SUBJECT: Cap Inspection Report; RACER Coldwater Road Landfill; Flint, Michigan;
MID 005 356 860; Waste Data System Number 393431

Cap Inspection Report

**RACER Coldwater Road Landfill
6220 Horton Street
Flint, Michigan
MID 005 356 860**

**FIGURE 1 - RACER LANDFILL, COLDWATER ROAD
LEACHATE REMOVED**

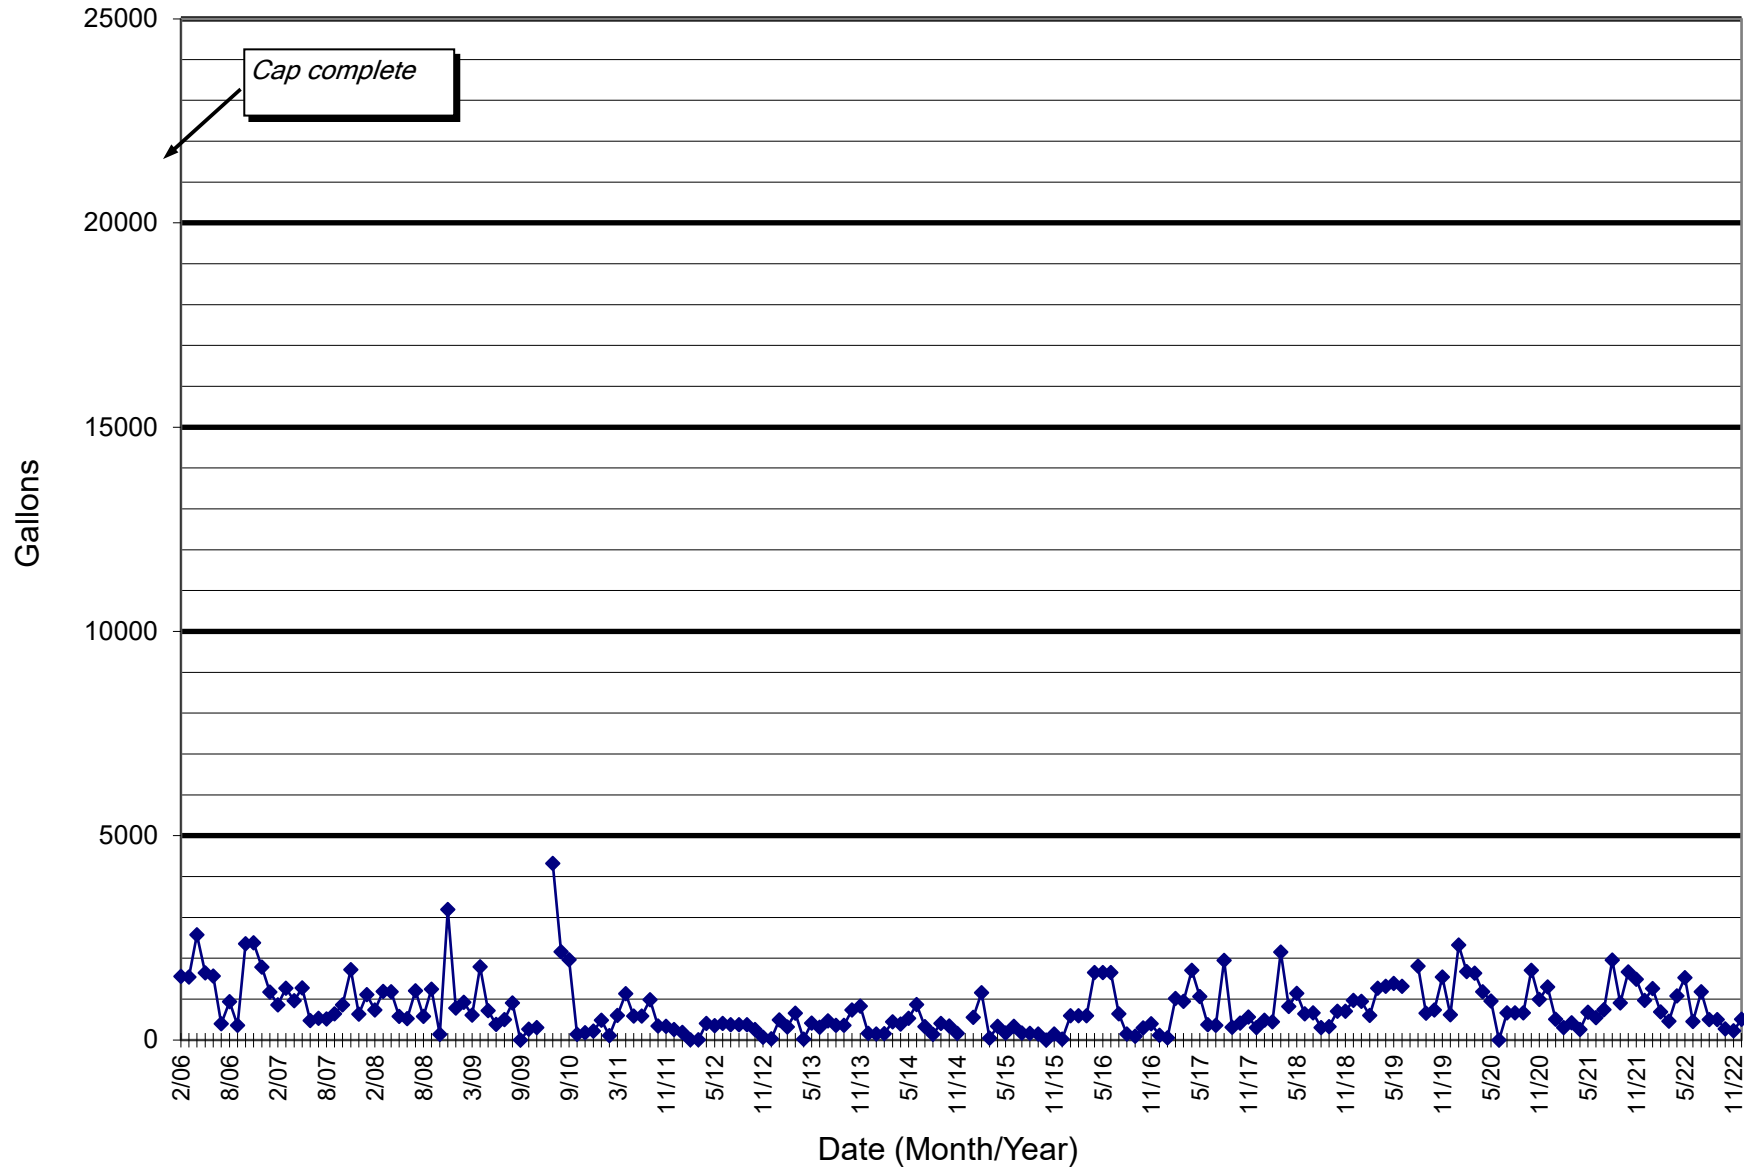
As can be seen in **Figure 1**, the volume of leachate pumped from the LCS has generally remained under 2,000 gallons monthly for the past twenty years (with the exception of several anomalous spikes). These data are as would be expected, and generally support satisfactory performance of the cap. It should be noted that, from the time period from

mid-2004 to mid-2005, accurate leachate generation volumes were unknown due to problems with the flow meter used to record the volume of leachate and leak detection liquid pumped to the accumulation tank. This problem was resolved in mid-2005. Since that time, recorded leachate volumes have increased slightly as compared to data from 2000 to 2004; however, it is unknown how much of this minor increase is due to a more accurate flow meter. Leachate flow volume monitoring will continue as required by the approved Postclosure Plan.

FIGURE 2 - RACER Coldwater Road Landfill Leak Detection System Water Removal

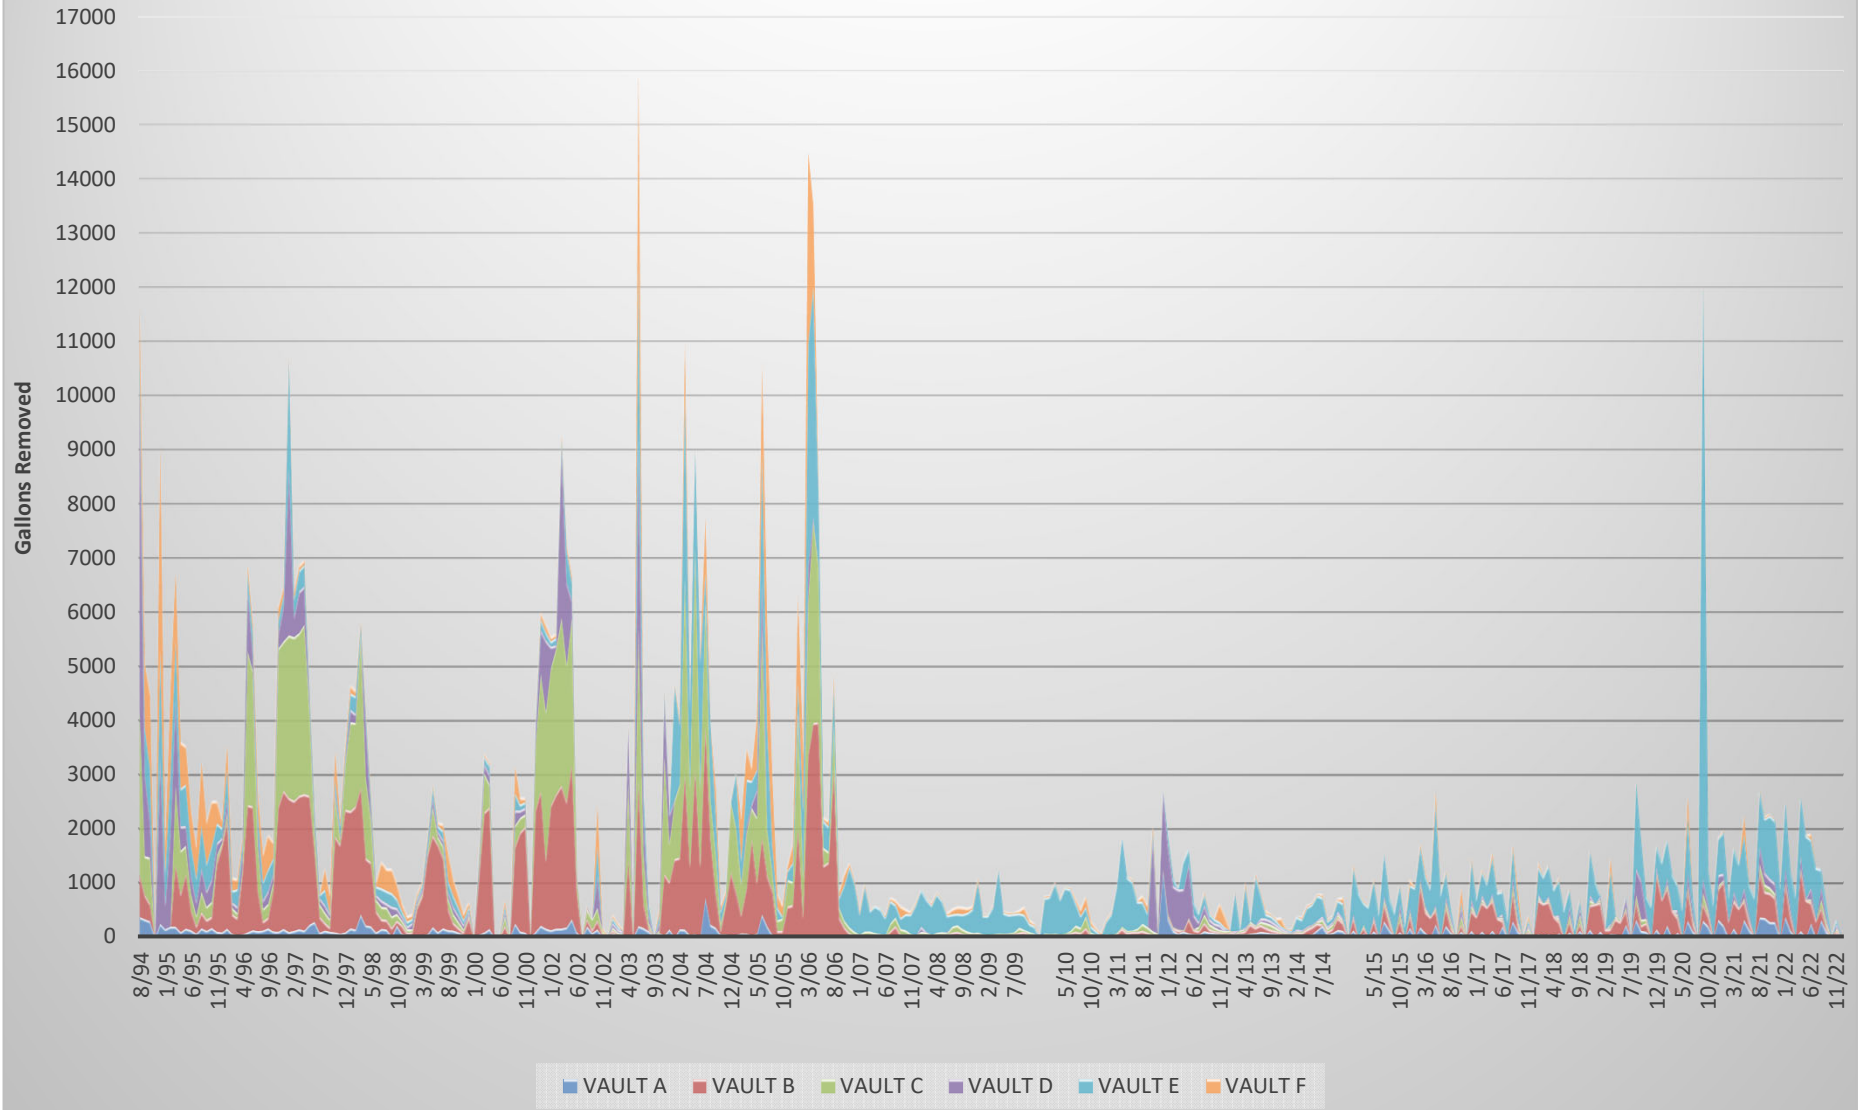
Due to the historical continual presence of excessive water in the LDS sumps, in August 2003 the MMD requested that the facility investigate the source of the water infiltrating into the LDS. From 2003 to 2006, the facility conducted several investigations and implemented several repairs that substantially reduced the volume of water infiltrating and being recovered from the LDS. This improvement can be seen graphically in **Figure 2**. This is especially pronounced for Vaults B and C where monthly recovered volumes have been reduced from thousands of gallons to under one hundred gallons.

SITE PLAN

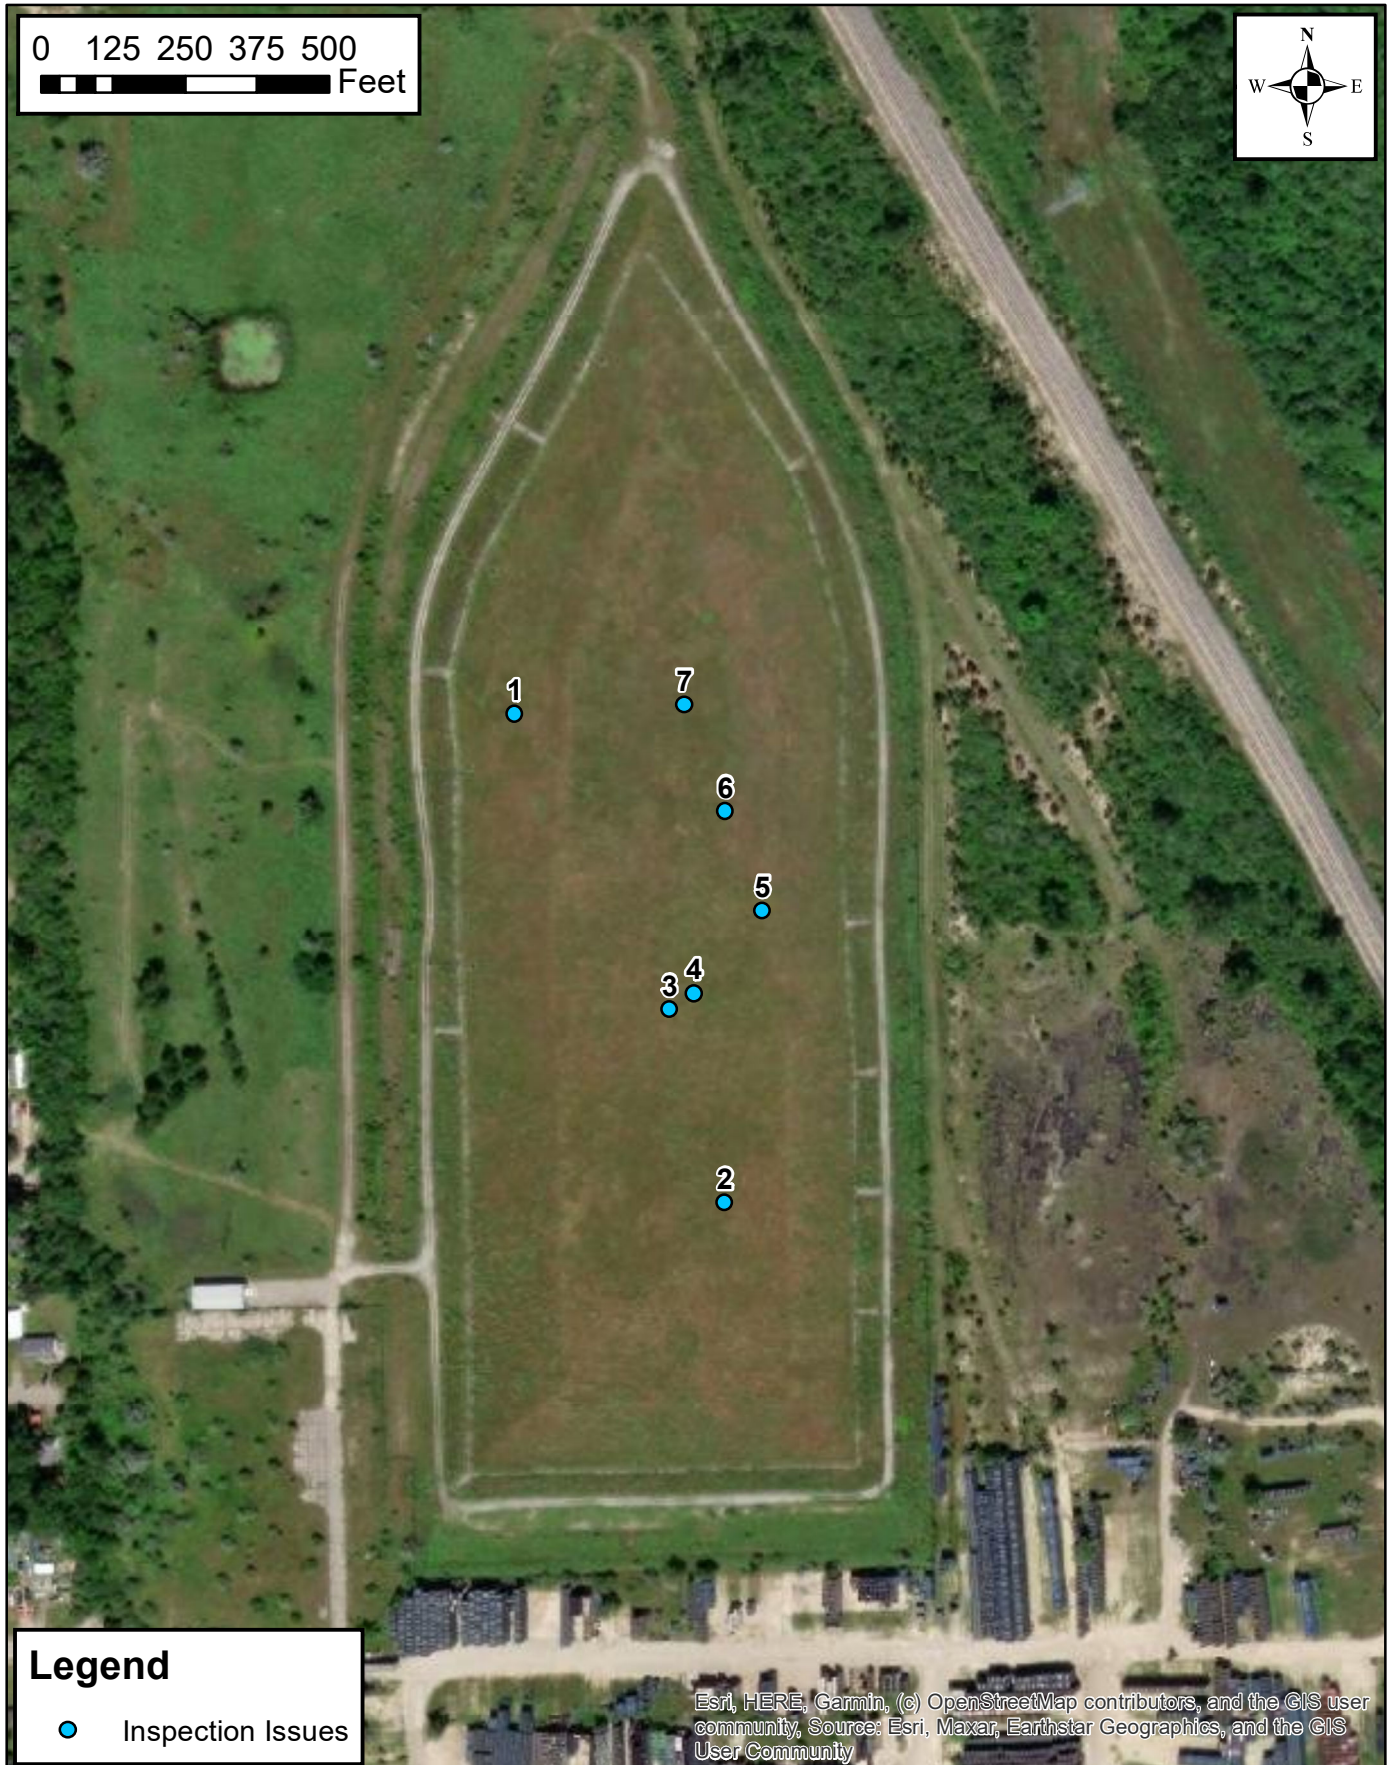
1. **Overgrown Vegetation:** Vegetation on the entire cap was extremely overgrown making it difficult to assess cap integrity.
2. **Small Woody Plants:** Several small woody plants were noted at various locations across the cap. The exact location of the area is noted on **Attachment 1**, and is documented in a photograph provided in **Attachment 2**.

1. **Overgrown Cap Vegetation:** Cap vegetation must be regularly maintained at a height that will provide sufficient protection, but will not hinder inspections of the cap.
2. **Small Woody Plants:** The various small woody plants indicated in **Attachment 1** must be removed from the cap. Photo-documentation of the repaired area must be provided within 30 days of receipt of this report.
